Old Steam Plant Steam and Condensate Pipe Replacement University of South Carolina Project H27-Z338-B

Addendum One

February 15, 2018

BACKFILL DETAIL

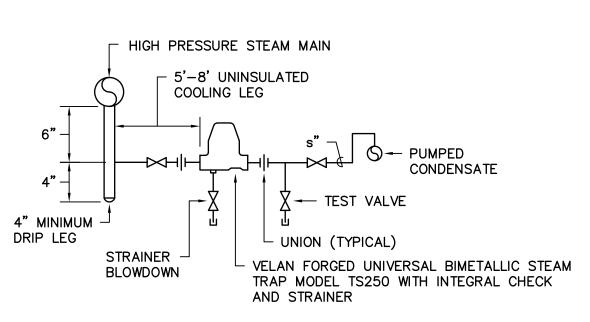
1. <u>Revision:</u> Reference Drawing M2, Details, Notes, Manhole Diagrams, and Legend. A detail for backfill at pavers has been added.
